Access Compliance Report

Public Rights-of-Way

(Curb Ramps)

Intersection ID: 48696	Main Street: MONTGOMERY_GARDENS_DR	Cross Street: BEATTIES_FORD_RD	Location: E
ADA ID: 3E67E68B91DE	Ramp Type: PerpDiag	Initial Pass/Fail: Fail	Overall Compliance: No
Severity Score: 21.25			
Codes/Mitigation Info/Possible Solution		Field Measurements/Component Compliance

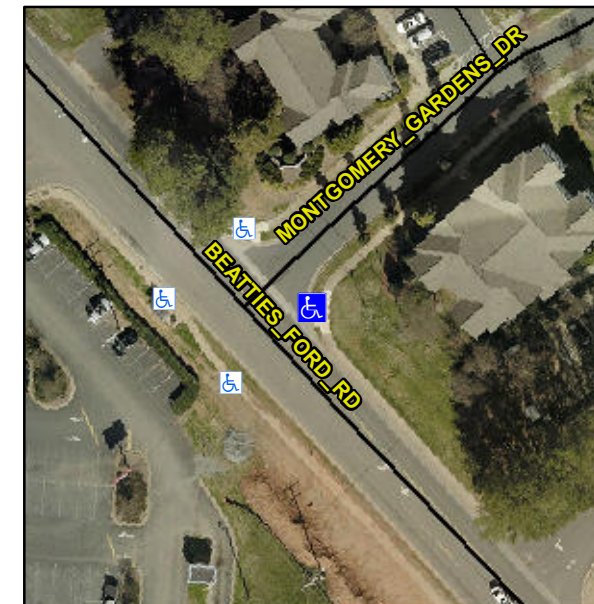
Not Found, R304.5.1, R304.2.2

Compliance	Description	Data	Compliance	Description	Data
N/A	Ramp Length (in)	48.0	No	Ramp Slope (%)	8.5
No	Ramp Width (in)	45.0	Yes	Ramp XSlope (%)	1.9
N/A	Flare Type LT	N/A	N/A	Flare Type RT	N/A
N/A	Flare Slope LT (%)	N/A	N/A	Flare Slope RT (%)	N/A
N/A	Flare Traversable LT?	N/A	N/A	Flare Traversable RT?	N/A
N/A	Landing Length (in)	N/A	N/A	DWS Provided?	N/A
N/A	Landing Width (in)	N/A	N/A	DWS Contrast?	N/A
N/A	Landing Slope (%)	N/A	N/A	DWS Length (in)	N/A
N/A	Landing X Slope (%)	N/A	N/A	DWS Full Width?	N/A
N/A	Landing Curb? (Y/N)	N/A	N/A	DWS Offset (in)	N/A
N/A	Shared Landing?	N/A			
N/A	Gutter Ponding?	N/A	N/A	Gutter Slope (%)	N/A
N/A	Gutter Lip Ht (in)	N/A	N/A	Gutter X Slope (%)	N/A
N/A	Painted X Walk1?	No	N/A	Painted X Walk2?	No
	X Walk 1 Direction	To NW		X Walk 2 Direction	To SW
N/A	X Walk 1 Width (in)	N/A	N/A	X Walk 2 Width (in)	N/A
	X Walk 1 Slope (%)	0.1		X Walk 2 Slope (%)	2.3
	X Walk 1 X Slope (%)	3.2		X Walk 2 X Slope (%)	0.8

Remove & Replace Curb Ramp With Two New Directional Ramps or Equivalent.
